New bulb in the roof sign illumination

Applicable to vehicles with roof sign illumination except CR19T.

Fig. 1. The old reflectors.

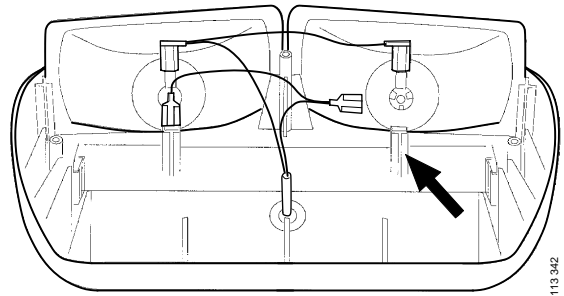
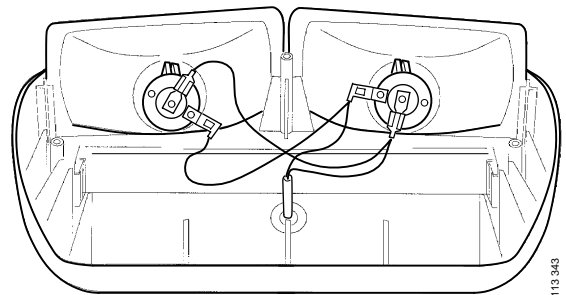
It has been reported that the roof sign illumination bulb has a short service life.

The existing bulb is replaced with a new standard bulb 21 W HD (Heavy duty).

When replacing the old bulb with bulb 21 W HD (Heavy duty), the roof sign illumination reflector must also be replaced.

Note: The plastic retainers must be removed in order to clear enough space for the new reflectors. See illustration 1. The easiest way to do this is with cutting pliers.

4. Fit the new reflectors with the new bulbs and connect the cables.
5. Reassemble the roof sign illumination.
6. Reconnect the negative cable to the battery.
